## Design Note

### 101 Albert Street - Foundation and Retention System Changes

**Project Name:** 101 Albert Street  
**Project No:** 22131  
**Document No:** ALB-RBG-DNT-ST-00-000-01

Figure 1 - Proposed Bulk Excavation Diagram

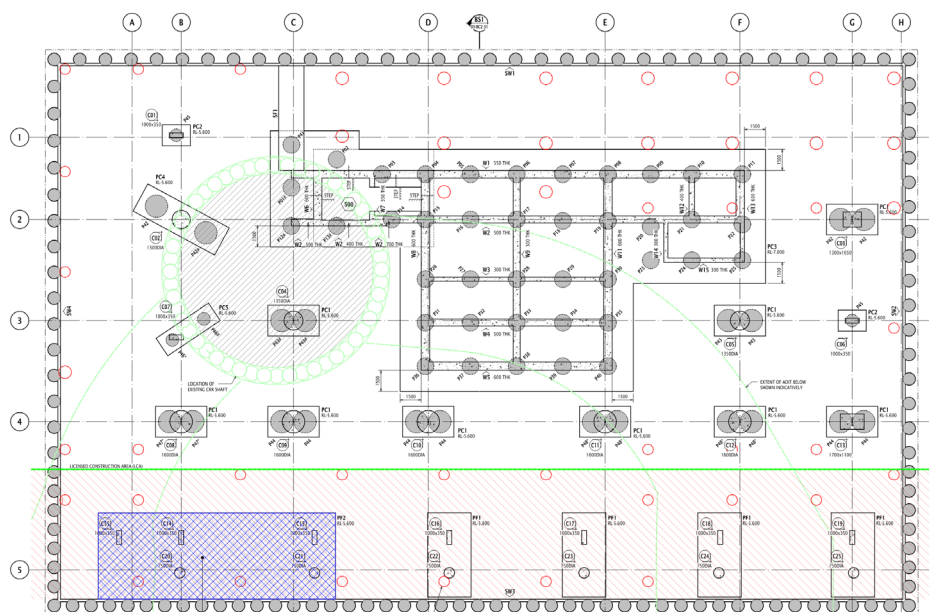
- i. The current Geotechnical advice which informs the structural design is based on a desktop study. Project specific Geotechnical investigations will be undertaken once the site is accessible. This existing geotechnical borehole information indicates a local zone of weaker material to the Albert Street, north-west corner, within the RL-8m maximum continuous excavation zone (denoted by red hatch in Figure 1), where the extremely weathered rock drops away. There is a risk that the founding material in this area (denoted by blue hatch in Figure 1) is residual soil which would impact retention system piles and column foundations in the area.

Due to the potential for weaker material, ground improvement works may be necessary within the LCA (i.e below RL-8m). These works would be restricted to the base of some of the pad footings and would involve controlled localised excavation, and replacement with N20 mass concrete. Where works are expected below the RL-8m maximum continuous excavation zone, it is proposed to be undertaken in stages with a maximum excavation depth of 2m and 3m<sup>2</sup> area.

Similarly, due to the potential weaker material, it is necessary to extend the retention system piles along this frontage below the RL-8m to RL-10m.

Figure 2 - Proposed Detail to Break Down Existing Piles

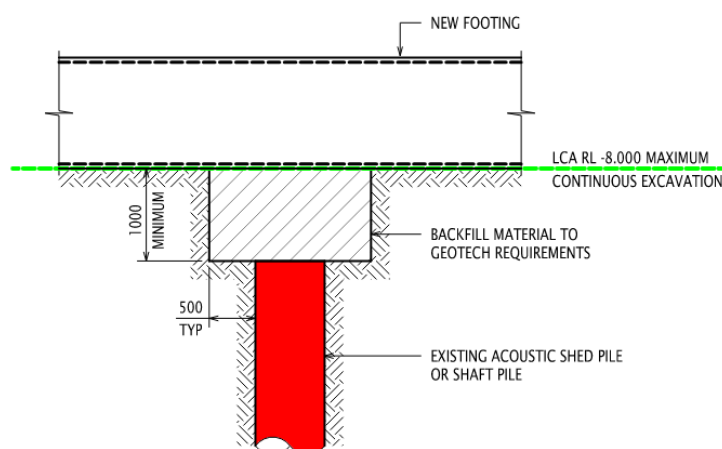
- ii. There are existing acoustic shed piles across the site that are currently documented to remain. These extend from current ground level to below the future basement depth and terminate in medium to high strength rock. Some of these piles terminate in close proximity to the CRR Cavern. Due to this, there is a risk that these piles could act as stiff points and be loaded by the future foundations.

To mitigate this risk, it is proposed to remove of the tops of the piles below RL-8m to remove possible interaction with future foundations. The pile and surrounding materials will be replaced with an engineered backfill material to be confirmed by the Geotechnical Engineer.
